## Application for Licence Amendment

<b>Licence Number</b>	L8739/2013/1
<b>Licence Holder</b>	Cable Sands (W.A.) Pty Ltd
<b>ACN</b>	009 137 142
<b>File Number</b>	DER2014/000656-1
<b>Premises</b>	Wonnerup Mineral Sands Mine 109 Sues Rd YALYALUP WA 6280  Being Lot 100 on Deposited Plan 65306, Mining Lease M70/360 and M70/569 and part of Miscellaneous Licences L70/159 and L70/161, as depicted in Schedule 1 of the revised licence
<b>Date of Report</b>	4 March 2022
<b>Decision</b>	Revised licence granted

**Figure 3: Distance to residential receptors**

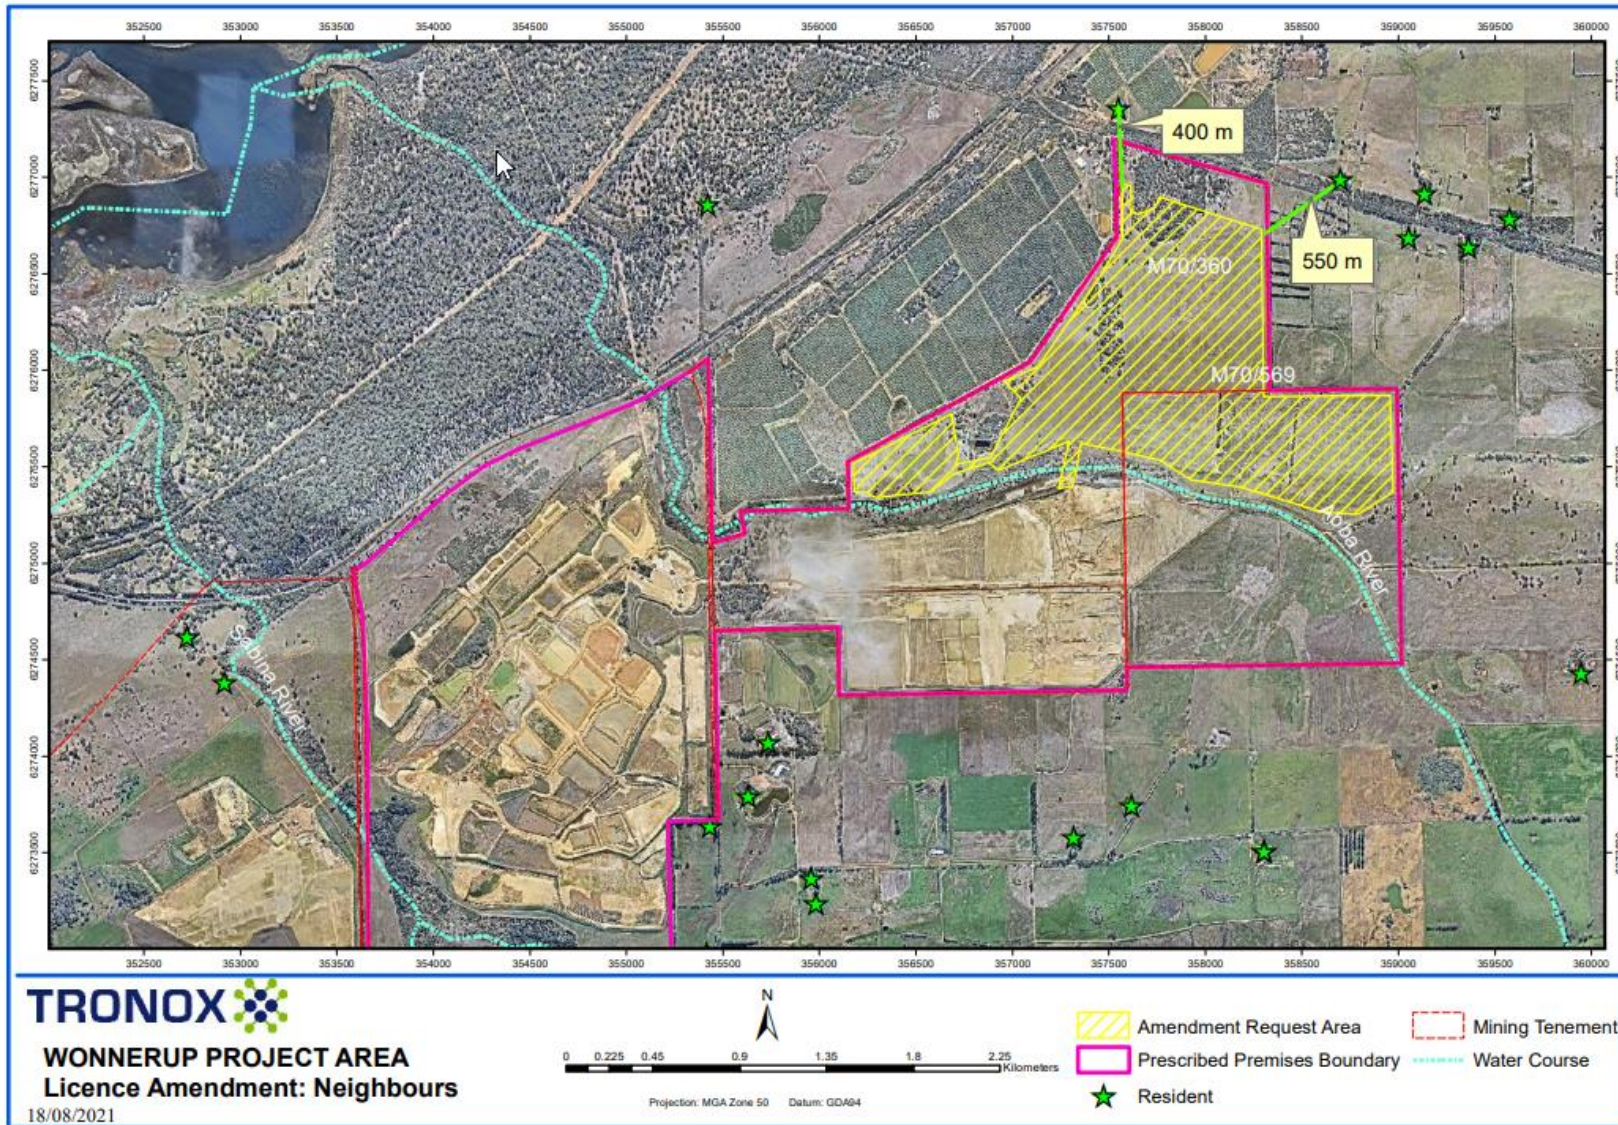
The locations of the closest residences are shown in Figure 3. The Licence Holder proposes two new dust monitoring sites (AQ9 and AQ10) for the phase B mining area.

There is one additional residential receptor directly north of the premises. This is farm worker accommodation rather than a permanent residence, but is still a receptor for this assessment. Although slightly closer than the receptors to the north east, this premises is screened by vegetation. Clearing Permit 8046/1 specifies this as outside the approved area of clearing, and gives rehabilitation objectives for this area. It is anticipated therefore that there will be less dust impacts to this residence than those to the north east, and with the dust management practices in place the Delegated Officer considers that additional monitoring to the north specifically for this residence is not justified at this stage. The Licence Holder advises that an amenity agreement with this landholder is close to finalisation.

**Figure 5: Schematic representation of the progression of mine voids**

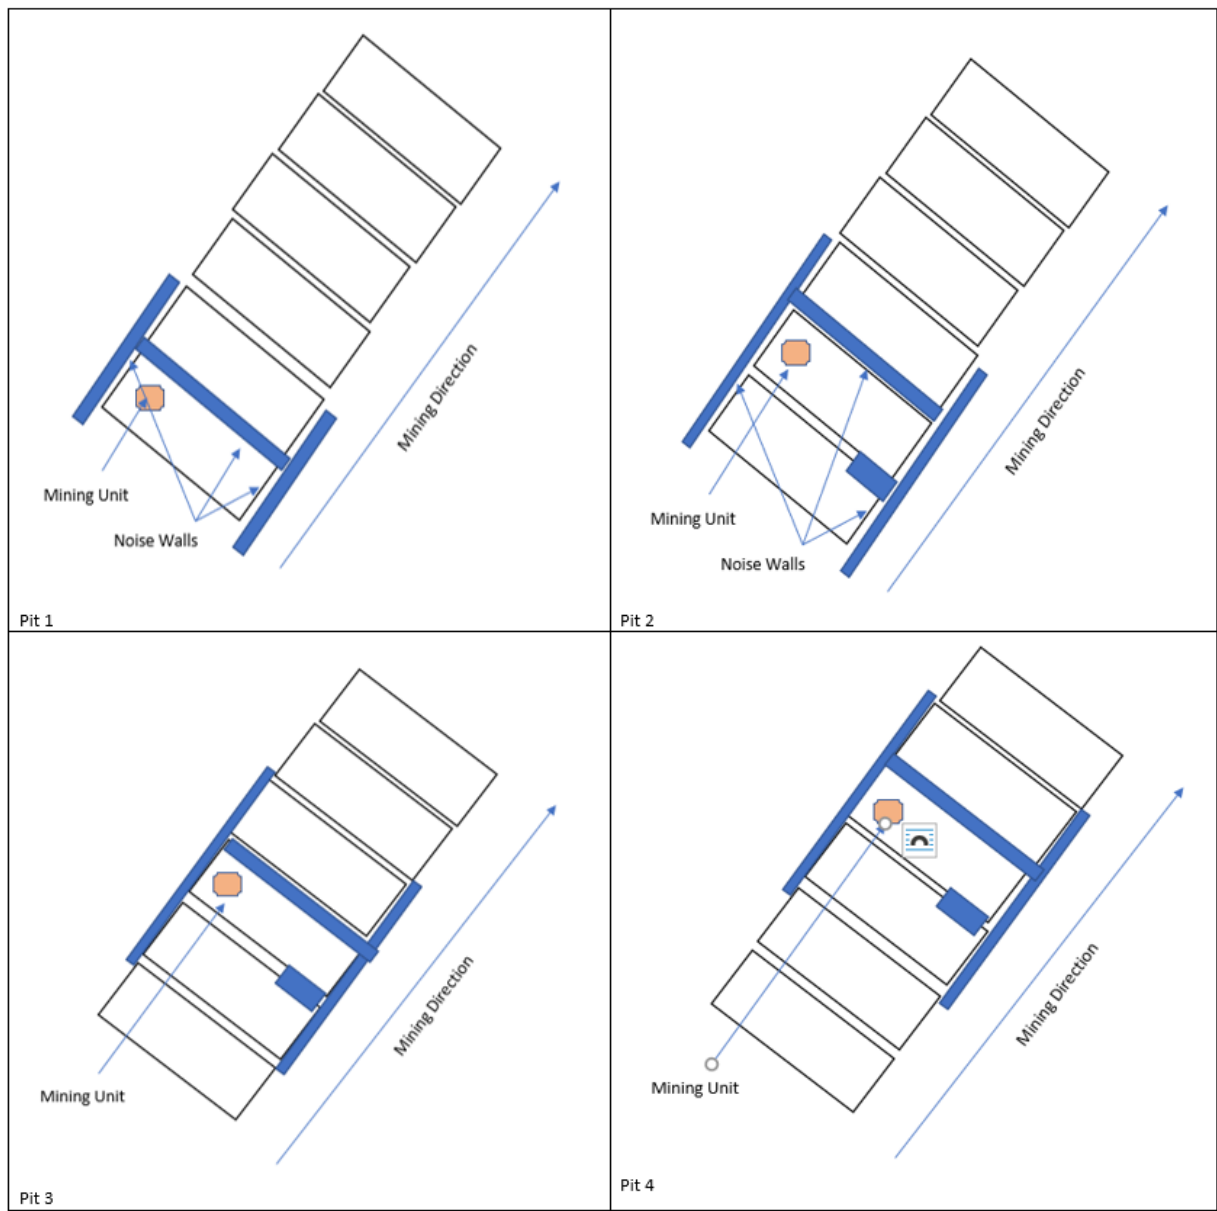
In previous mining areas, the Licence Holder has constructed bunds around the perimeter of the mining area before the commencement of mining operations. For Phase B It is still proposed that such bunds are constructed (as topsoil storage, and visual and dust screening), but not necessarily before the commencement of mining activities. The sensitivity analysis for Wonnerup North Stage 2 Phase A shows that the external bunds, being often a significant distance from the mining unit, have minimal impact on the reduction of noise to residence. The internal bunds within 30m of the mining unit, have a far more significant effect.

The modelling in the sensitivity analysis (Wood 2021) shows that most of the noise reduction due to bunding is achieved by internal ore bunds within 100m of the mining unit, and at least 100m in advance of the unit. This approach was approved for Stage 2 Phase A, and no noise complaints have been received by the department to date. The Delegated Officer is comfortable that this approach is also suitable for Phase B, with appropriate monitoring. The Delegated Officer therefore considers the proposal to allow construction of noise bunding progressively (at least 100m in advance of the mining unit) to be reasonable.

1.2.7	(M70/360) should be updated to (M70/569 and M70/360)	Agreed, updated.
2.5.1	<ol style="list-style-type: none"> <li>Existing row relating to noise bunding applicable for north of Abba River on M70/569 only, not M70/360</li> <li>Separate row proposed for M70/360 due to different mining direction relative to receptors</li> </ol>	<ol style="list-style-type: none"> <li>Existing row narrowed to relate only to north of Abba River on M70/569.</li> <li>New row added for M70/360, and bund descriptions corrected to reflect the direction of mining on this tenement. Bund map updated to indicate direction of mining, and diagrammatic explanation added to decision report.</li> </ol>

The general arrangements of bunds is shown in Figure 5. The short blue bund represents that there will be some residual of the previous mining area bund, which doesn't play a significant role in noise attenuation.
